ESFCU Germantown: Preliminary Plan No. 120160020 and Site Plan No. 820160170

Completed: 05/12/17

A. ESFCU Germantown: Preliminary Plan No. 120160020:

B. ESFCU Germantown: Site Plan No. 820160170:

Figure 5 – Open space, bike parking and sitting area

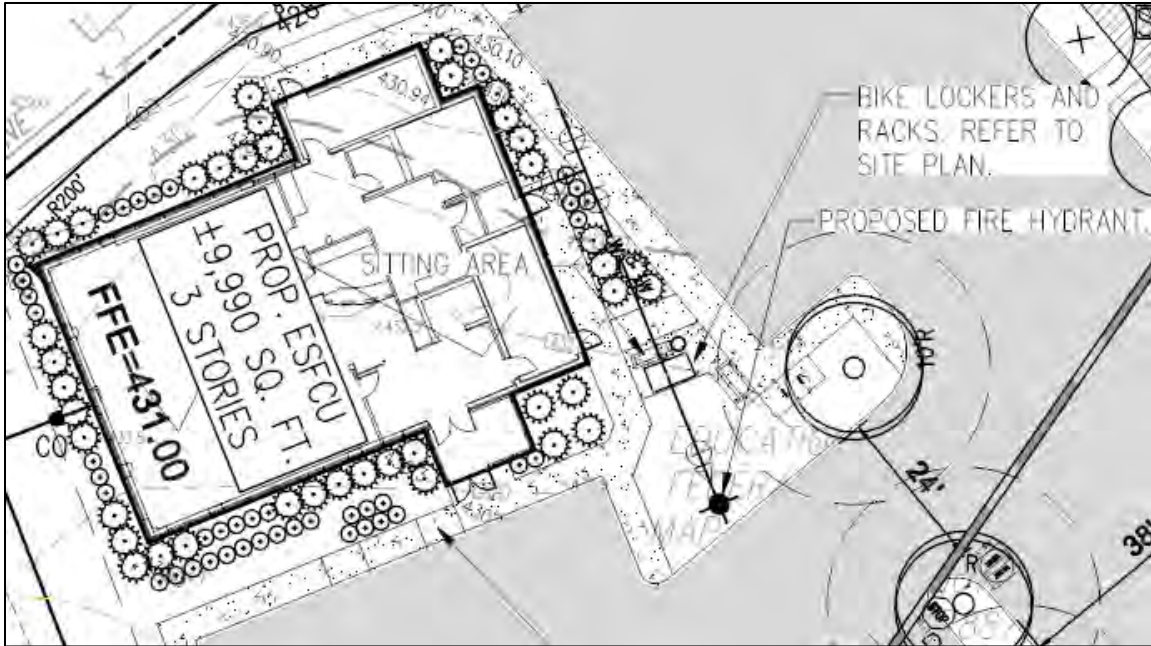
The provided open space is adequate for the Site Plan. The Zoning Ordinance requires that 10 percent or 7,362 square-foot of open space for this Property and the project proposes 26.3 percent or 19,367 square feet of open space. Included as part of the open space amenity is a seating area, located near the building entrance at the southeast corner of the building. There are no recreation requirements to be met on-site because it is a commercial use.

Figure 7 - Frederick Road Elevation

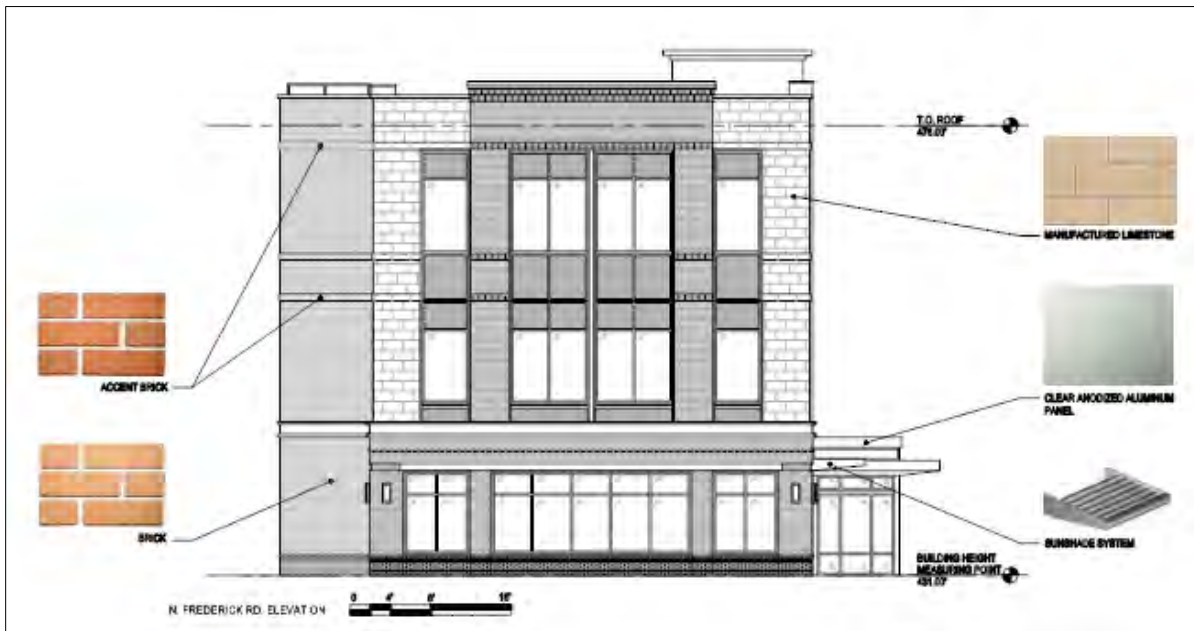
The building is located as close to the new property frontage line as possible, and is oriented to face south, toward northbound Frederick Road traffic, rather than directly west toward the road. The building orientation was necessary to allow a full building edge to have presence along the street and still accommodate the necessary access and front door visibility. The building location also meets all necessary setbacks from adjacent undeveloped and residential properties. The west building elevation, fronting on Frederick Road, avoids a blank wall appearance, and incorporates an attractive row of windows on all three levels of the building, as seen in Figure 7 below.

Figure 8 - Cross Section of Site

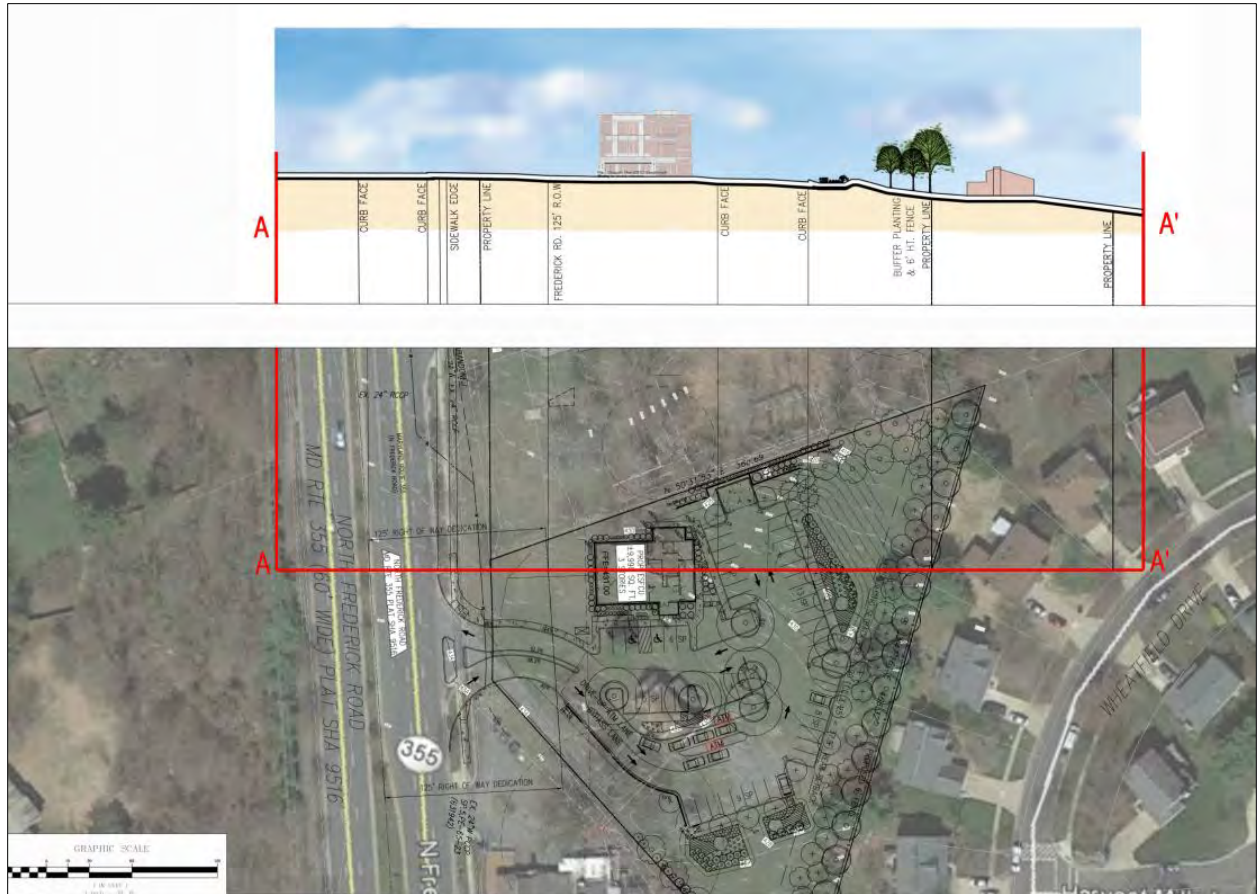
The proposed development is compatible with the adjacent single-family detached homes located to the east. The building and parking lot are located approximately 153 feet and 37.5 feet respectively, from the abutting residential properties. The Site Plan also maintains the minimum 100-foot setback of any vehicle queuing area front a residential use. A six-foot high privacy fence and a mix of trees and other landscaping is along this boundary, consistent with the screening requirements under Section 59.6.5.3.c.7. Landscaping will also be provided along the boundaries with the undeveloped Property to the north, and along the Property to the south.

52" Elm Tree with "V"
Notches and no central
leader

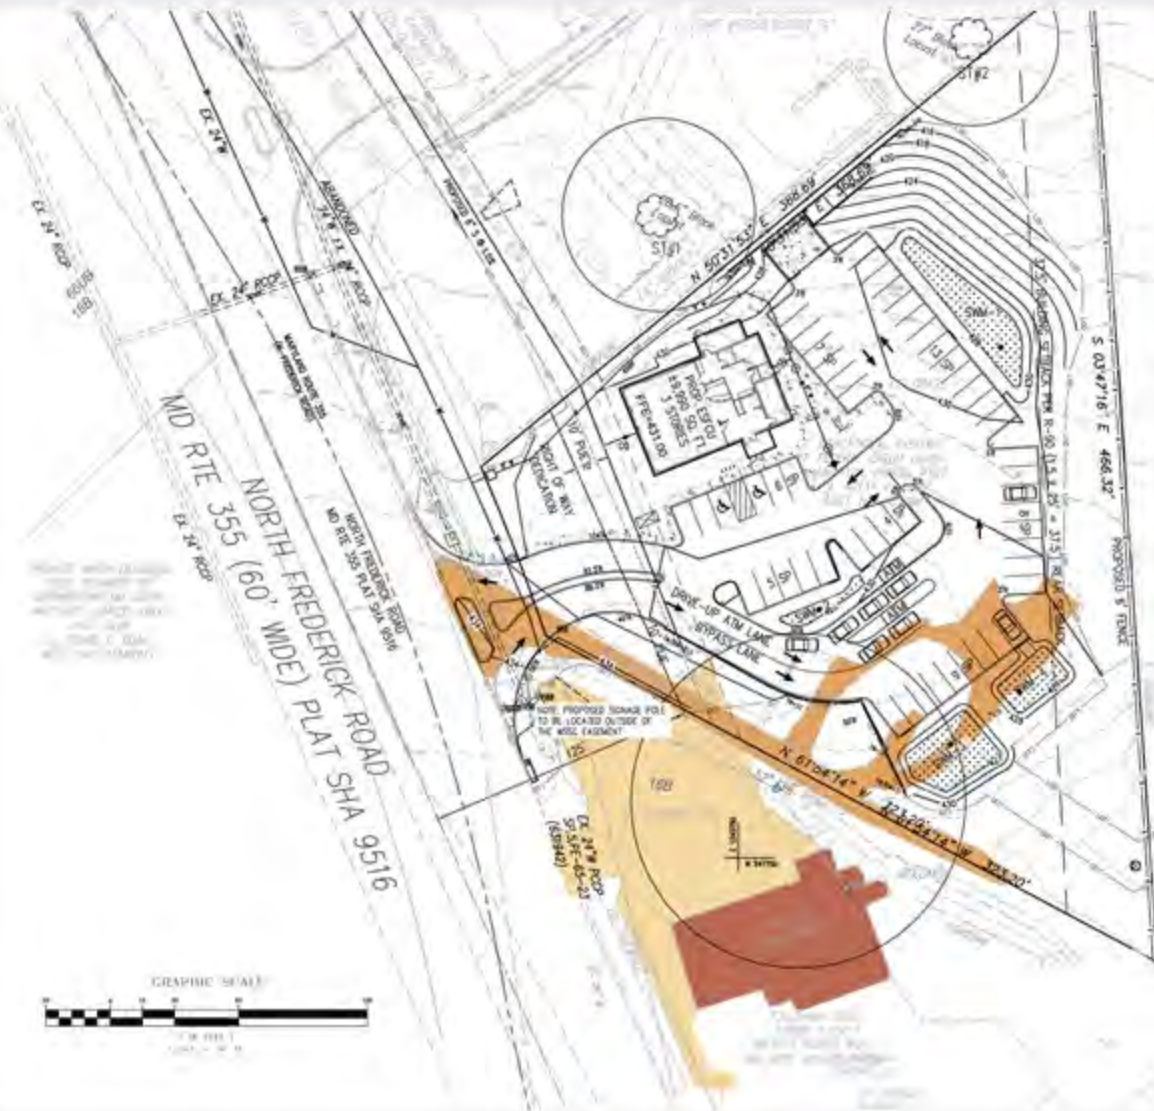
The subject tree is located under the existing overhead power utility line that runs just offsite adjacent to the southern property line. Over the years, the main trunk lateral and half of the tree's canopy has been cut away (Exhibit B). The removal of the main trunk lateral and canopy trimming is a result in typical power company trimming technics. The irregular canopy depends upon the stability of the tree's two existing "V" forks or unions. The attached photographs show how deep the bottom "V" fork intrudes into the main trunk. Typically, these types of "V" forks/unions become susceptible to disease, fungus and rot. The impacts to the subject tree are starting to manifest with the existing conditions:

- This tree is a hazard to adjacent life and/or property and will only to continue to decline/become more of an issue during and after proposed construction. In our opinion, this tree is in poor to very poor condition using the ISA Council of Tree & Landscape Appraisers Guide for Plant Appraisal methodology and should in fact be removed.
